# Project Modifications Document

Cochrane Solar Project

JANUARY 2019

Appendix B – Engineering Drawing

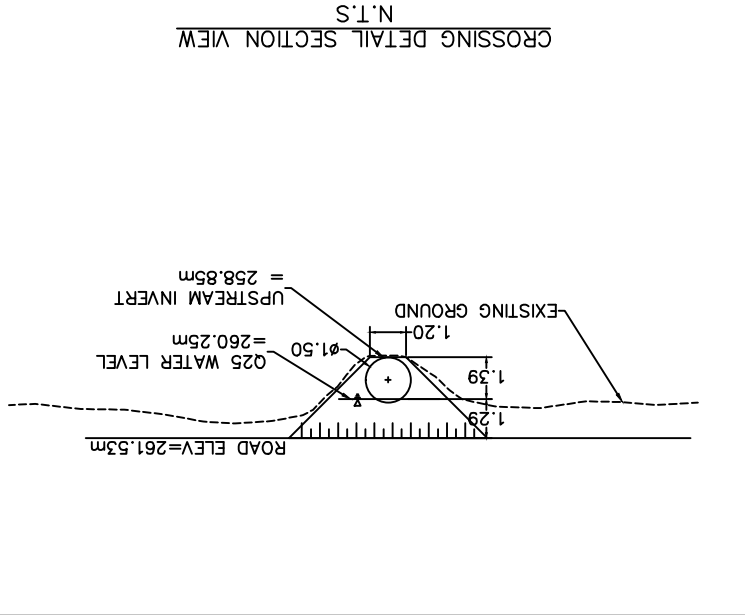
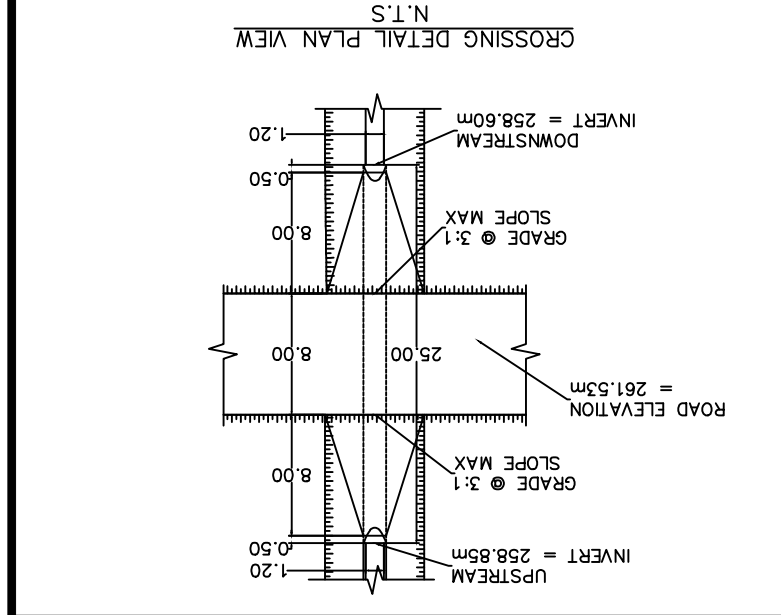
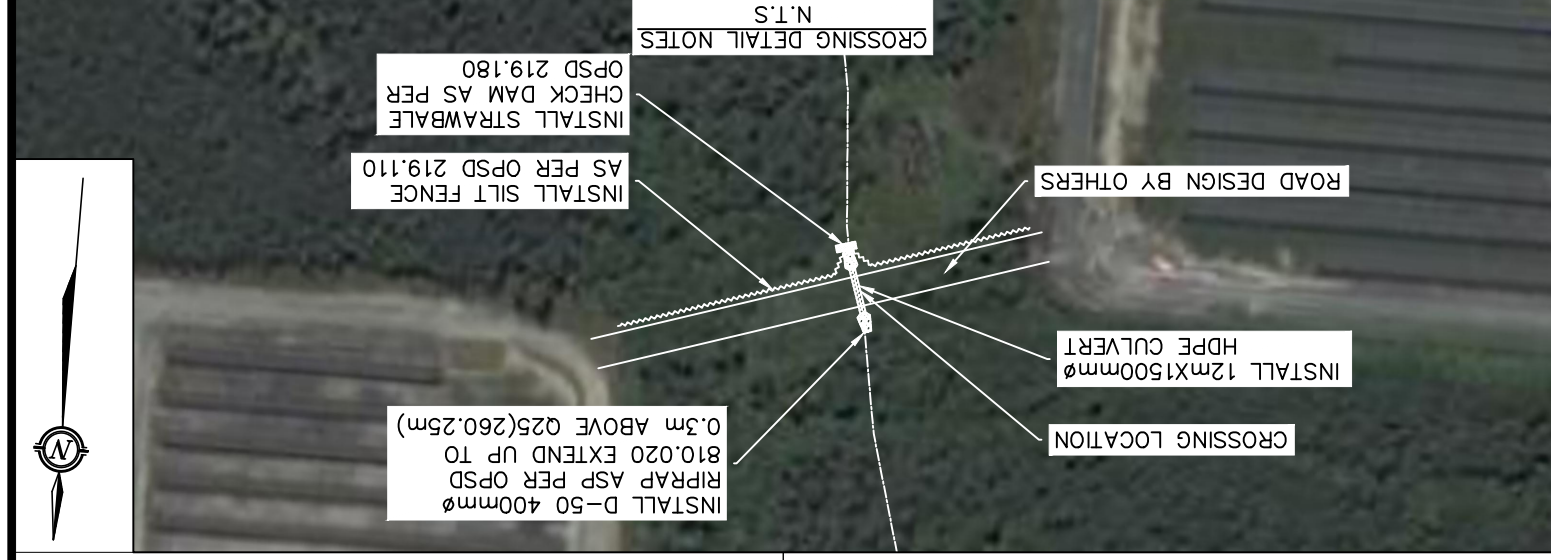
The proposed Project change is the addition of a 112-m long, granular surface access road between the Empire and Martin's Meadows project areas. A 25-m long, 1500 mm diameter HDPE (smooth interior surface) pipe will be required to cross an unnamed intermittently flowing tributary of Munroe Creek. The design drawing for the water crossing structure is provided in **Appendix B**.
